Pentium[®] Pro Processor Specification Update

Release Date: May, 1997

Order Number 242689-018

Specification Update for 150 -, 166-, 180-, and 200-MHz Pentium® Pro Processors

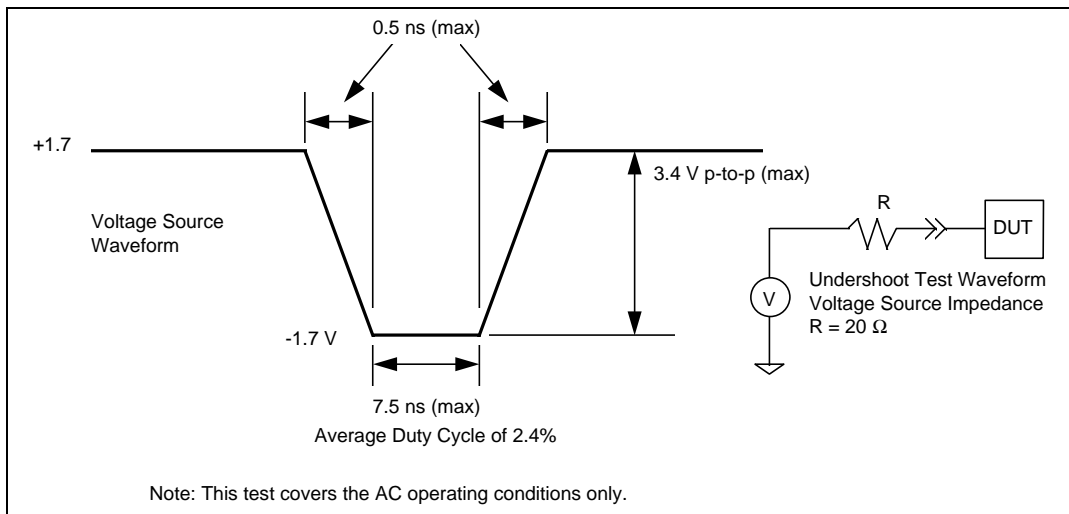
- While Intel has done nothing to prevent different frequency Pentium Pro processors within a system from working together, there may be uncharacterized errata which exist in such configurations. In mixed stepping systems, all processors must be run at an identical frequency (i.e. the lowest frequency acceptable to all components).

- The workarounds for various errata must take all processors into account.
- Errata for all processor steppings present in a system will affect that system, unless worked around.

- The following notes apply only to specific combinations:
 1. The 150-MHz and the 166-, 180-, and 200-MHz parts vary in their GTL+ T_{CO_MIN} and T_{HOLD} timings by 250 ps. This may affect some system designs. Also, a customer may wish to use a higher frequency replacement for a 150-MHz processor in a 150-MHz system; this should also be considered.

2. OverDrive[®] processor upgrades for the Pentium Pro processor will only be supported in one and two processor systems, and are only supported in same stepping configurations.

3. Errata numbers 39 and 41 may be problematic for 3 - or 4-way MP systems which use processor steppings previous to the sA1 stepping.

In the following table, "NI" implies that there are currently no known issues associated with mixing these steppings. An "X" implies that these steppings should not be used together in a system. A number indicates a known issue, and refers to the numbered list above. There are no currently known issues associated with mixing cache sizes.

Figure 4-3. Stack Switch on a Call to a Different Privilege Level

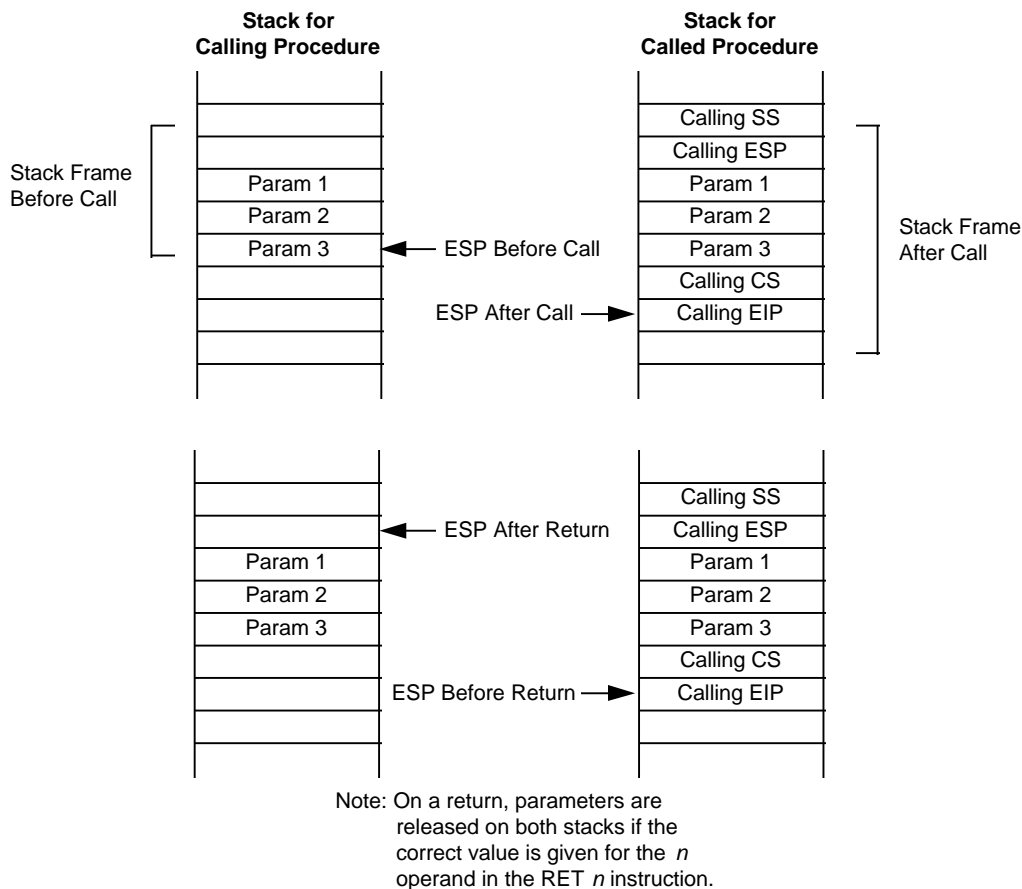
When making a call to a more privileged protection level, the processor does the following (see Figure 4-3):

4. Restores the SS and ESP registers to their values prior to the call, which causes a switch back to the stack of the calling procedure.
5. (If the RET instruction has an optional n argument.) Increments the stack pointer by the number of bytes specified with the n operand to release parameters from the stack (see explanation in step 3).

6. Resumes execution of the calling procedure.

Figure 4-4. Stack Usage on Transfers to Interrupt and Exception Handling Routines

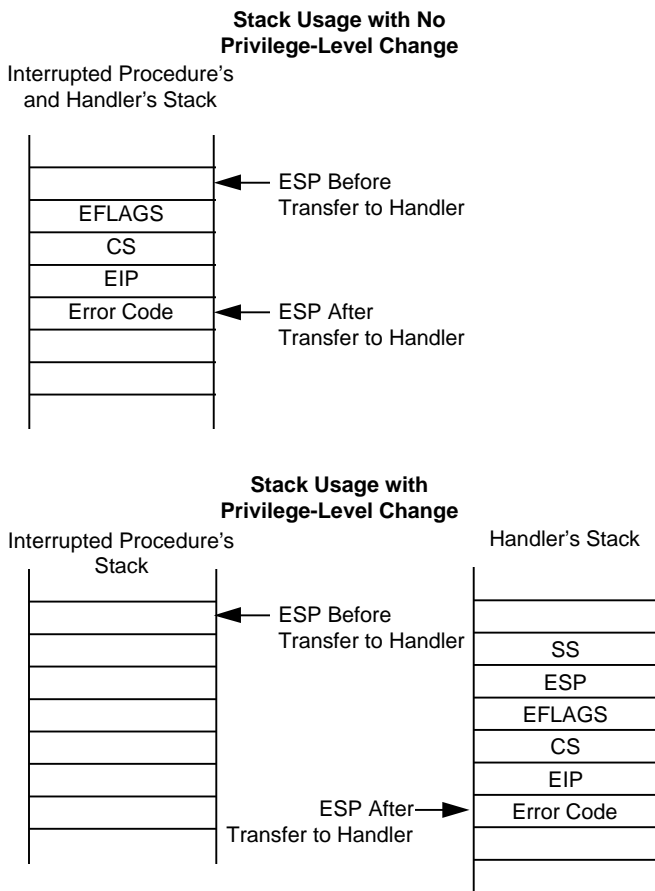
If no stack switch occurs, the processor does the following when calling an interrupt or exception handler (see Figure 44):

1. Performs a privilege check.

2. Restores the CS and EIP registers to their values prior to the interrupt or exception.
3. Restores the EFLAGS register.
4. Restores the SS and ESP registers to their values prior to the interrupt or exception, resulting in a stack switch back to the stack of the interrupted procedure.
5. Resumes execution of the interrupted procedure.
